Point Beach Nuclear Plant, Units 1 and 2
Dockets 50-266 and 50-301
Renewed License Nos. DPR-24 and DPR-27

License Amendment Request 261, Supplement 4
Extended Power Uprate

LICENSE AMENDMENT REQUEST 261, SUPPLEMENT 4 EXTENDED POWER UPRATE

TRAIN "A" DISTRIBUTION SYSTEM VOLTAGES

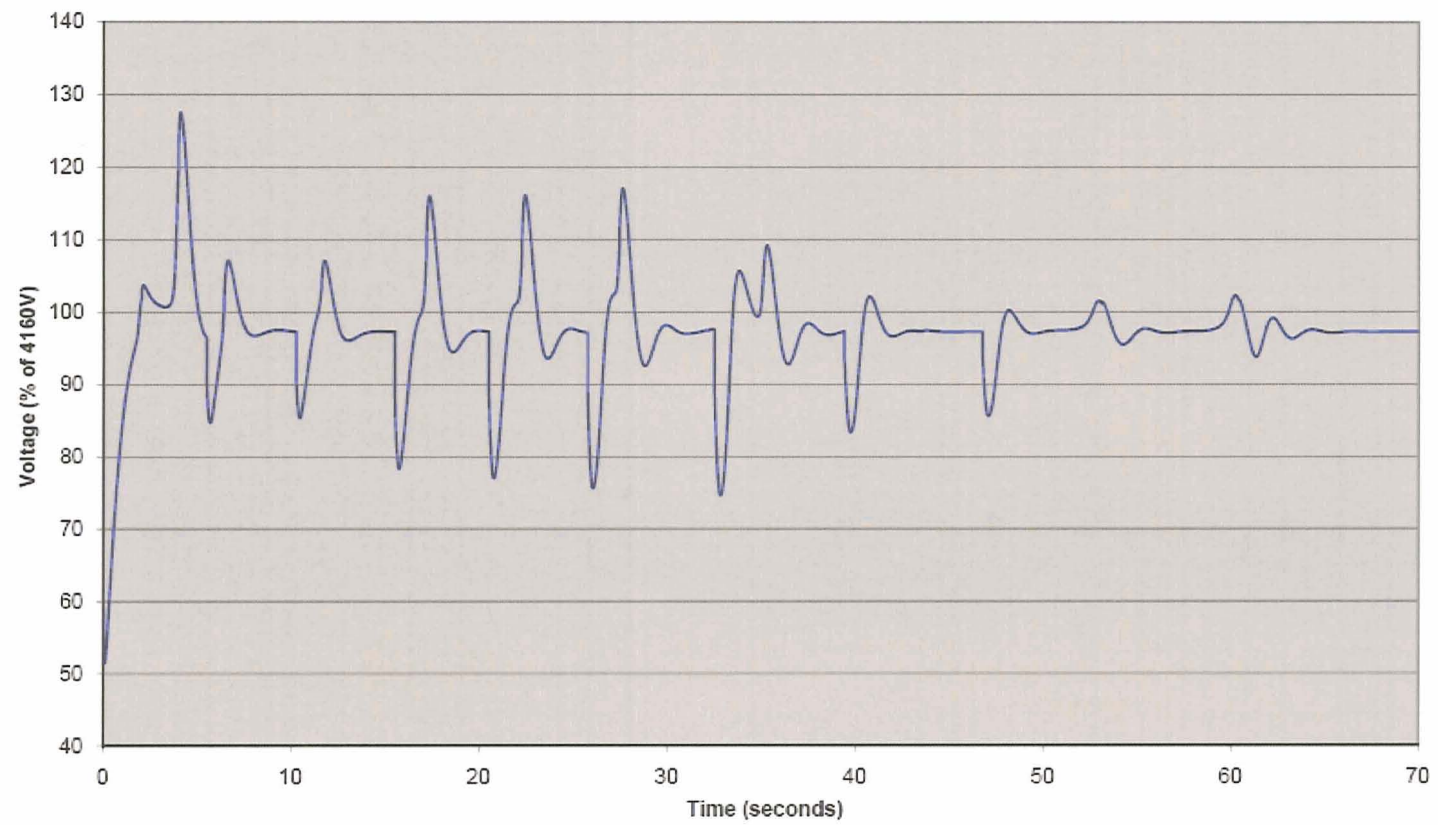
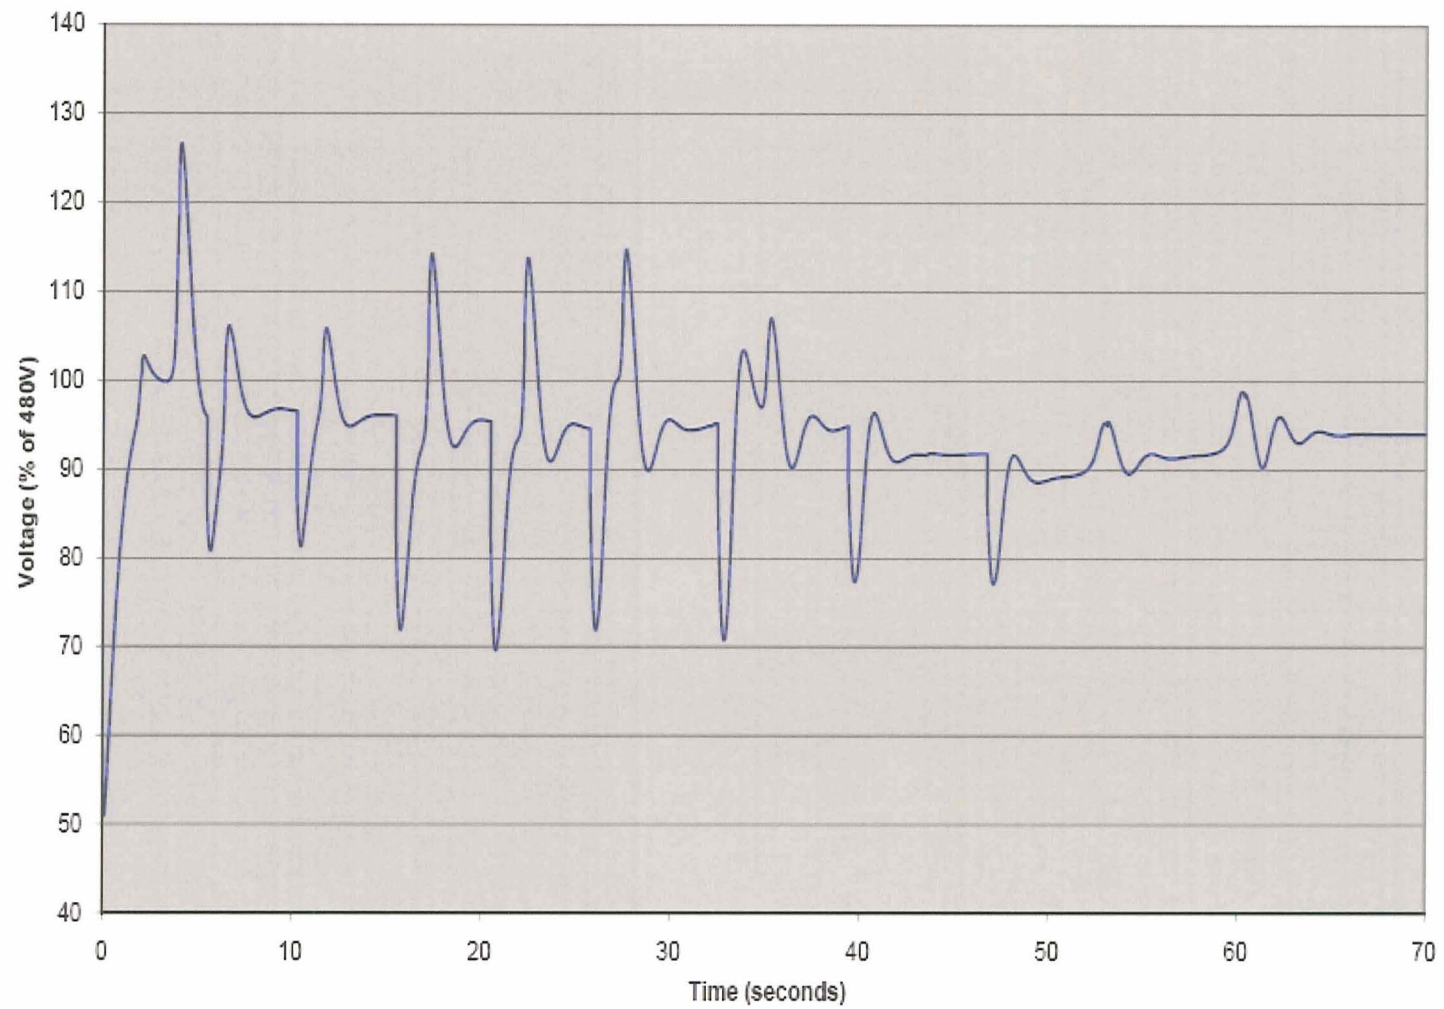
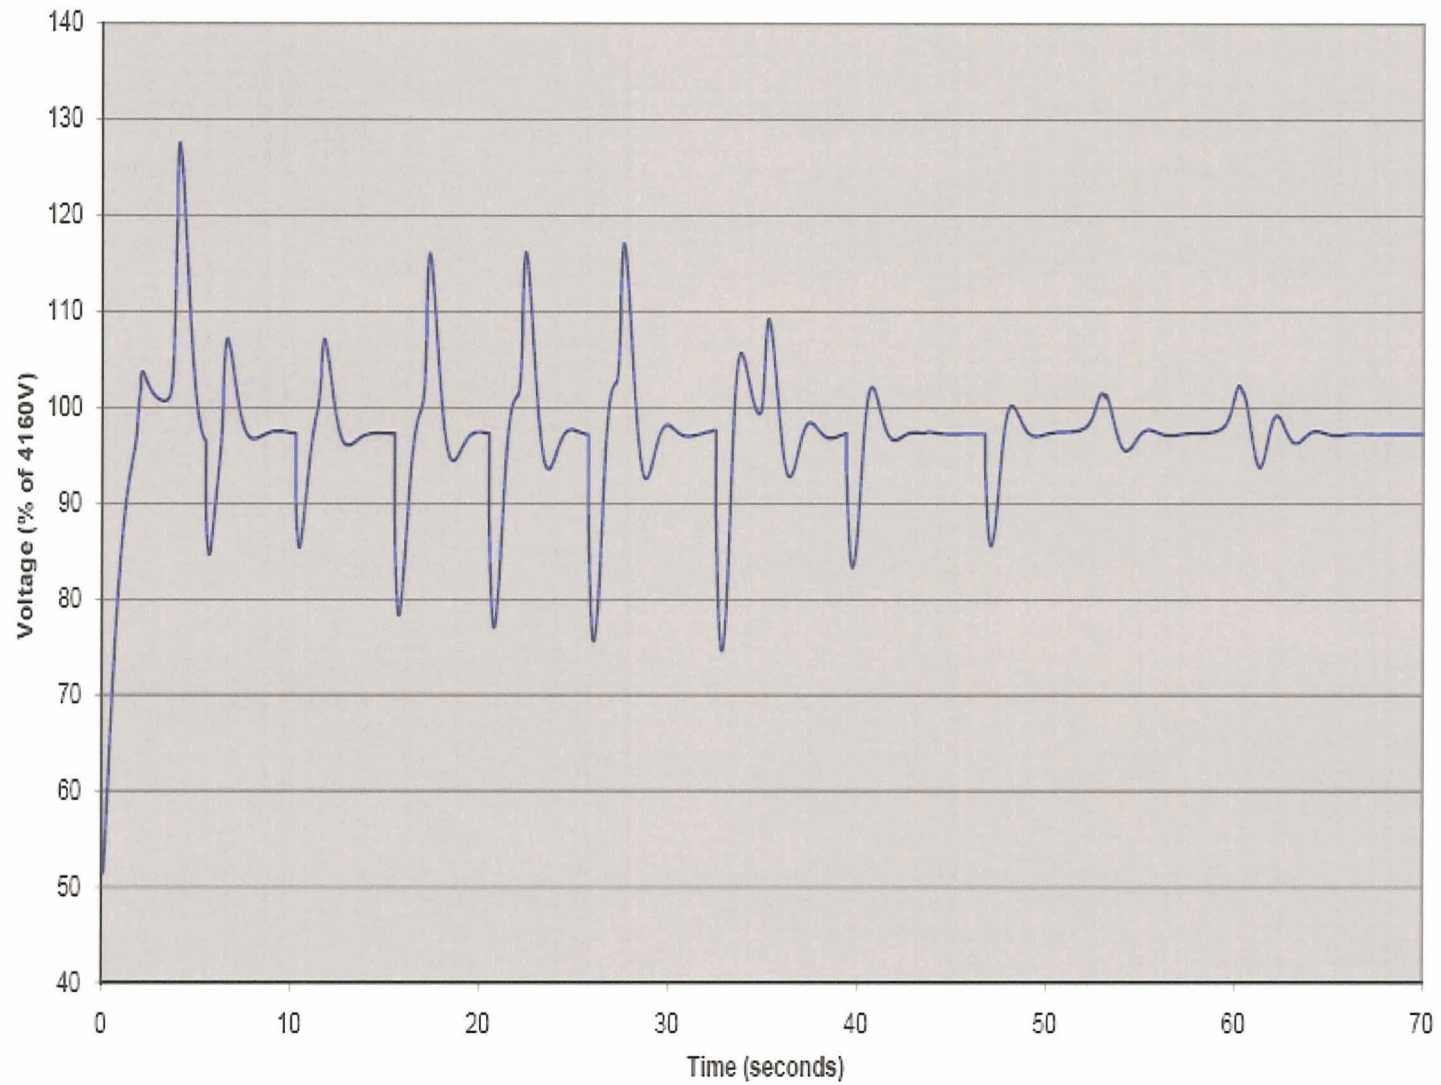
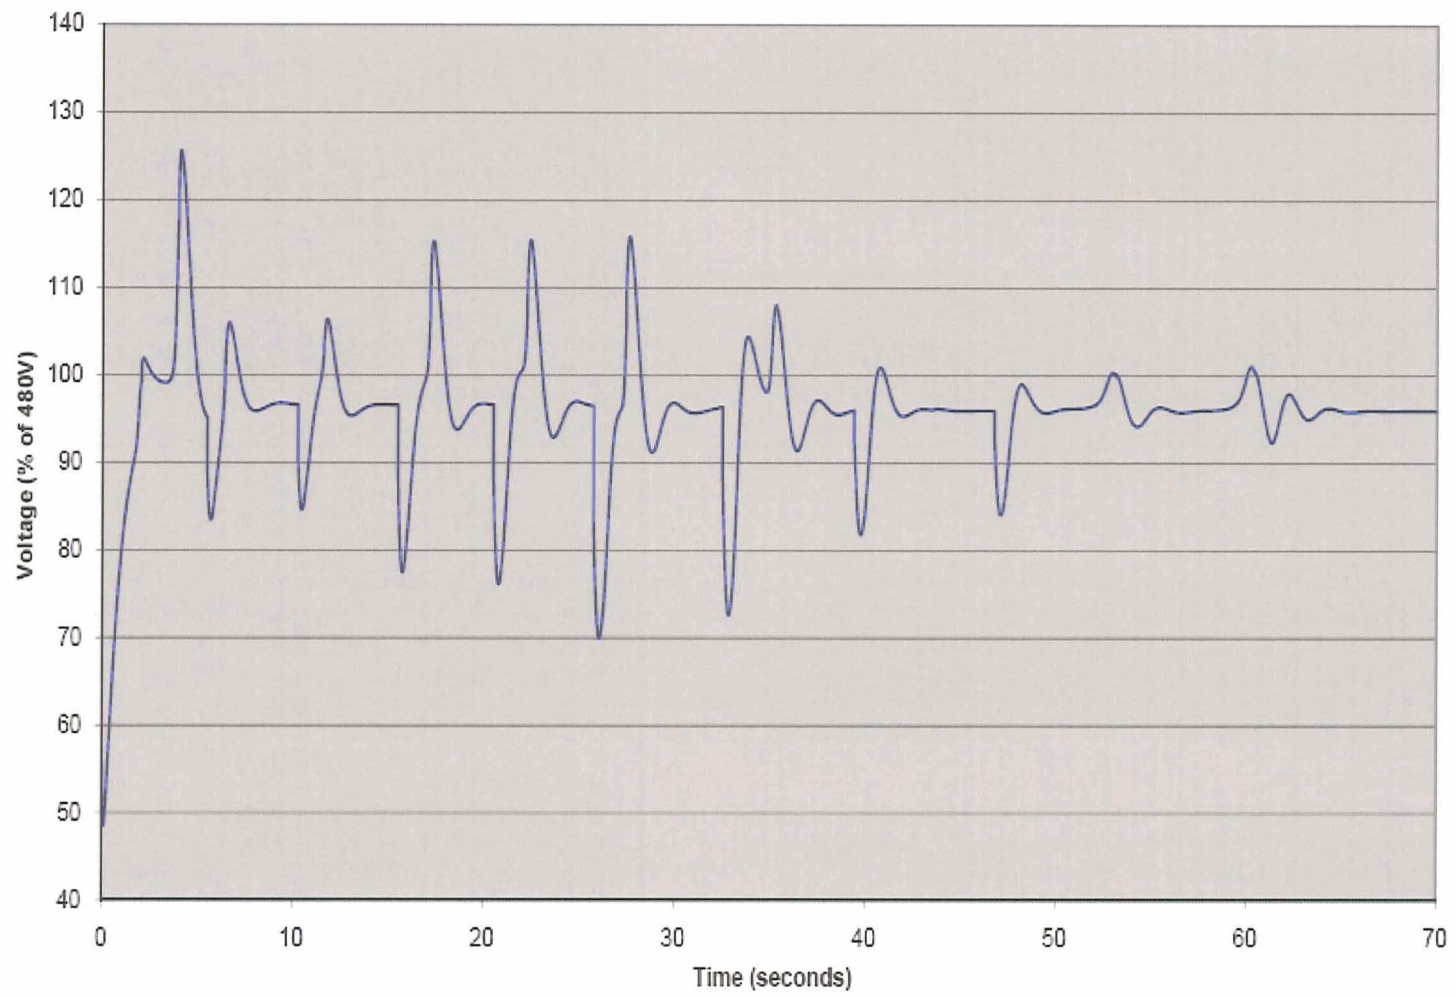
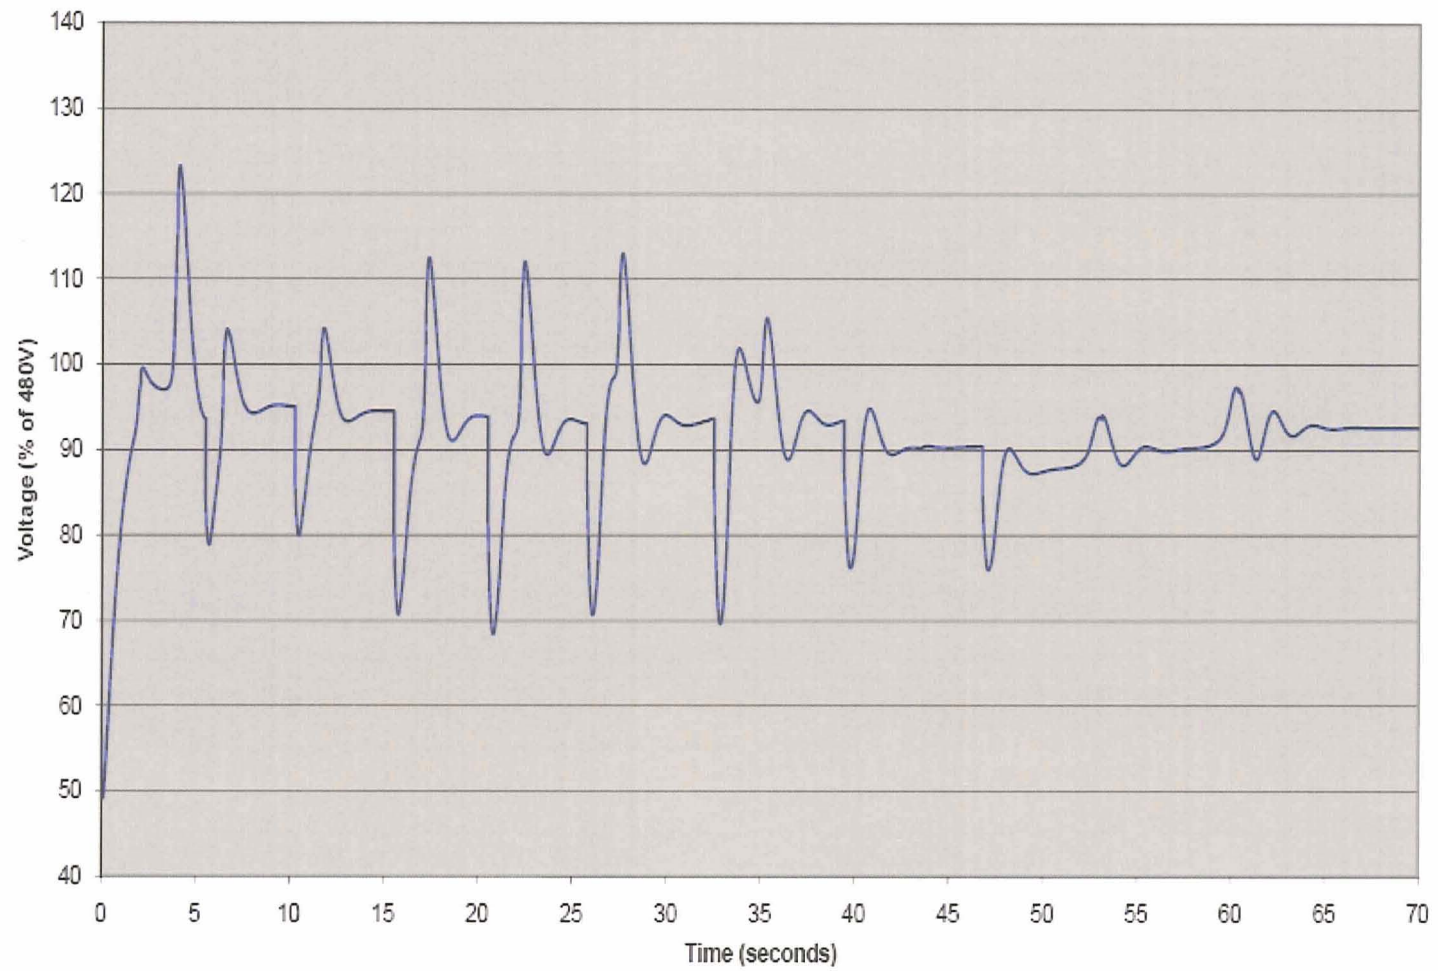
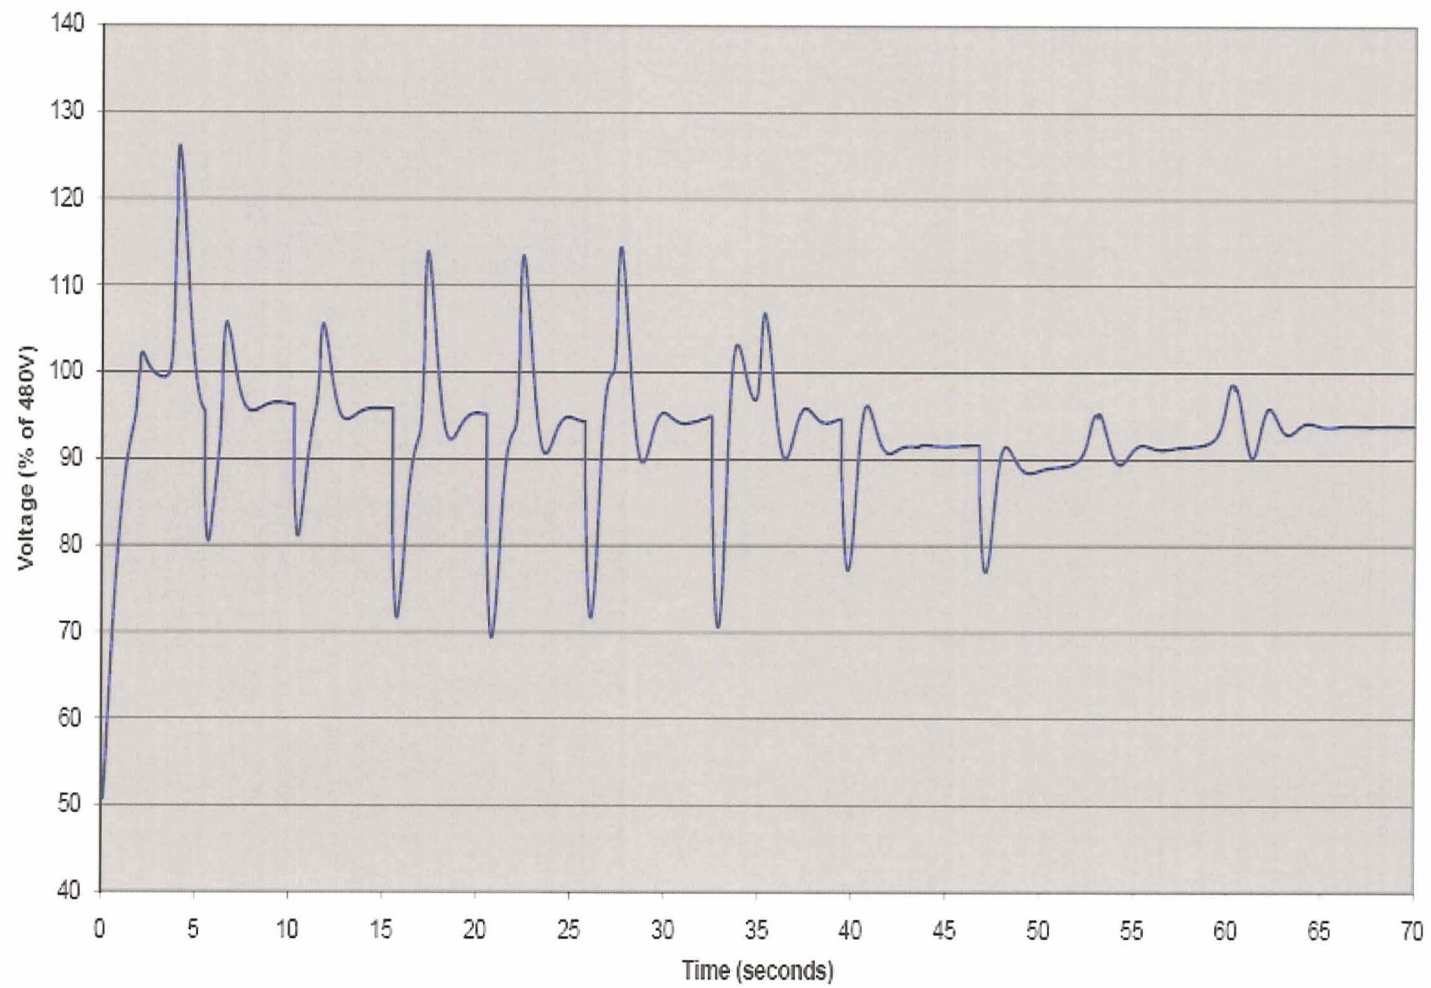
In response to staff's request for additional information (RAI) dated August 26, 2009, regarding the emergency diesel generator (EDG) voltage dip below the acceptance limit of 75 percent nominal voltage during motor start, the licensee stated that the EDGs are capable of starting safeguard loads, and the voltage recovers quickly to the acceptable level. Based on staff's review of the dynamic loading calculations, the staff notes that under certain loading conditions for Train "A" EDG, the frequency is outside 2 percent margin, the worst-case voltage dip is 45-48 percent and the voltage overshoot is 129.5 percent. Train "A" voltage and frequency variations are outside the industry accepted standards and guidance. Provide detailed analyses regarding the downstream effects on components such as contactors, control fuses, inverters, battery chargers, solenoids, motor-operated valves, solid state devices, etc., and the basis to show that all required loads will start and continue to run with sufficient margins after accounting for any uncertainties. Provide justification for the performance capabilities of the EDG "A" regulator and excitation systems to support shutdown equipment within design-basis requirements during a design-basis accident. The staff notes that Train "B" EDG bus voltages remain above 75 percent of nominal voltage, consistent with NRC Regulatory Guide (RG) 1.9, throughout the motor starting sequence in all postulated loading conditions. Provide a summary of all bus voltages for the 'B' train distribution system.

Attachment 3 provides a summary of bus voltages for the "B" train distribution system for the above large break LOCA design basis ETAP Cases.
